**TROTT BROOK CROSSING**  
Ramsey, Minnesota

**PRELIMINARY  
LANDSCAPE PLAN**

L1 of 4

Created by: Chris Anderson  
On: 10/08/2021 09:57 AM

1 OVERALL LANDSCAPE PLAN  
L1

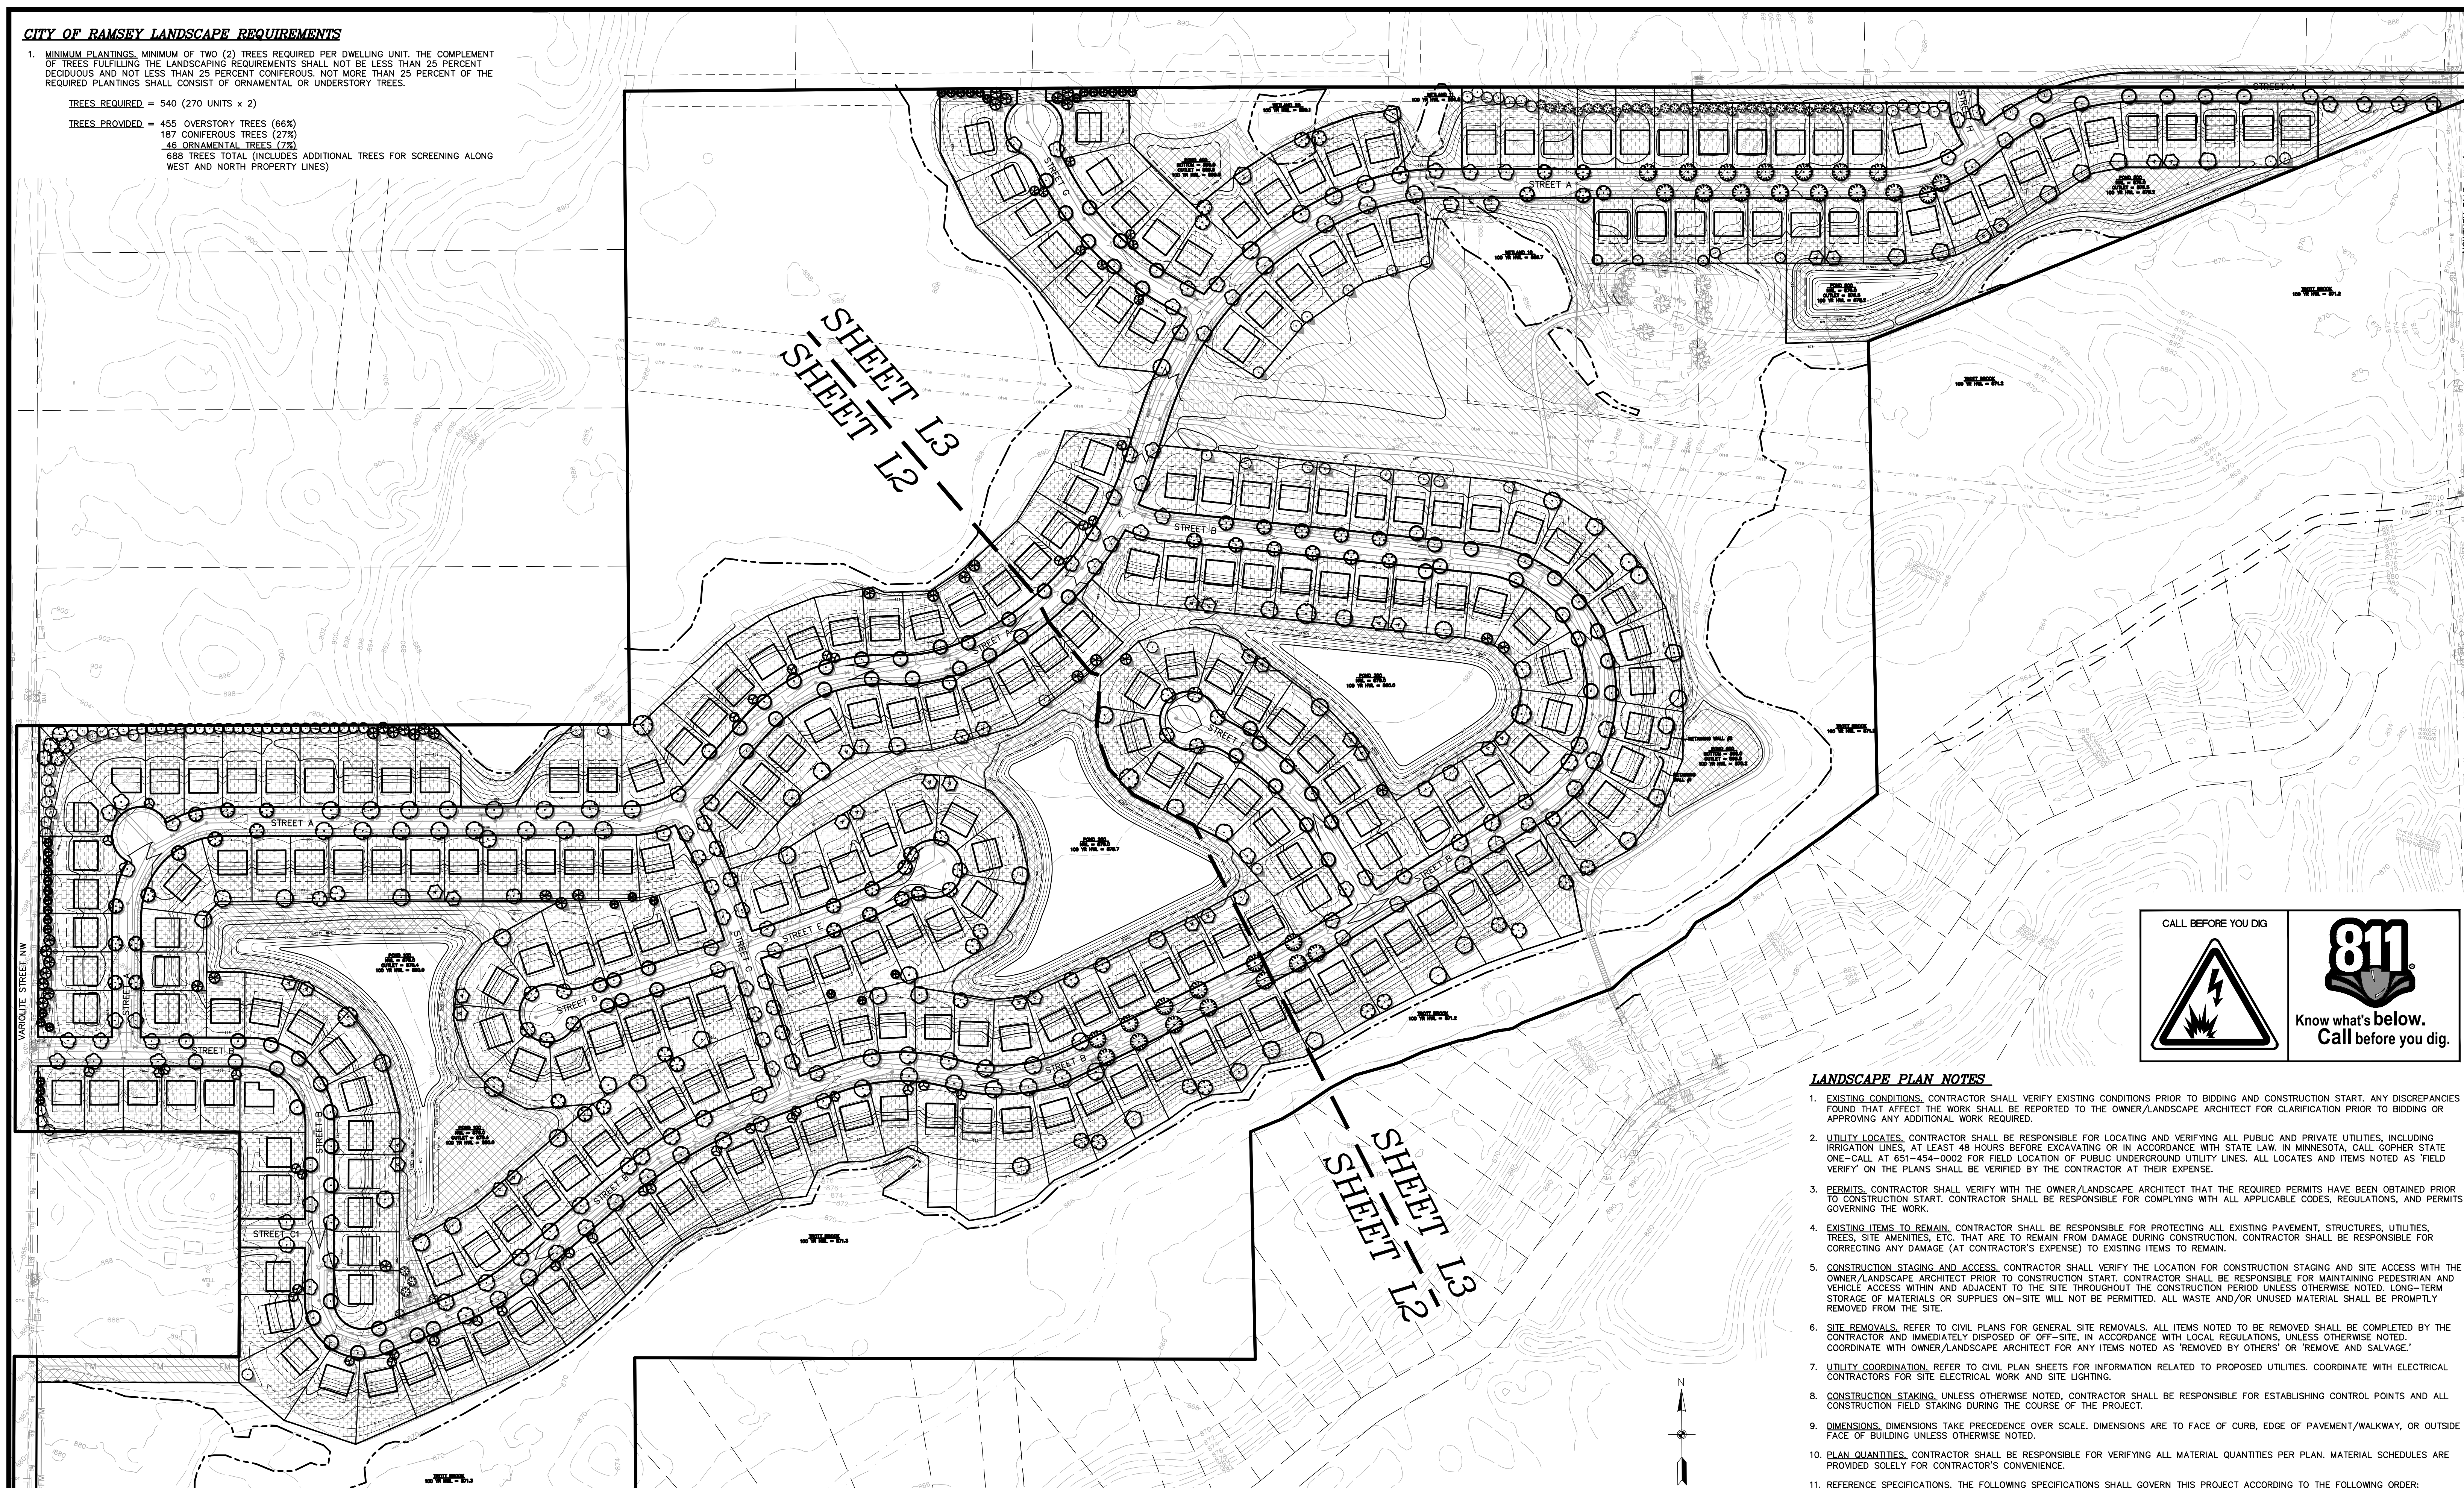
## 1 - Density Transitioning Requirements

Provide a 45 foot wide corridor (held in common ownership, typically done as an outlot owned by HOA) with 8 overstory trees, 8 evergreen trees, and 8 ornamental trees per 100 feet of impacted property OR provide a 35 foot wide corridor WITH a berm and 4 overstory trees, 4 evergreen trees, and 4 ornamental trees per every 100 feet of impacted property.

Additional plantings are required along this boundary. They should be in groupings and/or staggered rows.

## 2 - Landscape Requirements for R-1 Residential (MUSA) - 80 District

Each lot is to receive two (2) front yard trees, one (or both if there's space) can be placed in the boulevard and the other somewhere in front yard.

For the lots on cul-de-sac bulbs, where space is more limited, consideration may be given to a rear yard planting.

Revise plan accordingly.

## 3 - Sod

Sod is required in all boulevards. Where there is no sidewalk, sod is required within 10 feet of back of curb.

## 4 - Topsoil

All disturbed areas not otherwise improved with impervious surfacing (and stormwater ponds) shall receive 4 inches of topsoil. Topsoil shall not contain more than 35% sand.

## 5 - Irrigation

Should irrigation systems be installed, they must be equipped with a rain sensor and some form of water efficient technologies, such as a smart controller.

## 6 - Plant Schedule

Any modification to plant species requires approval of city prior to installation.
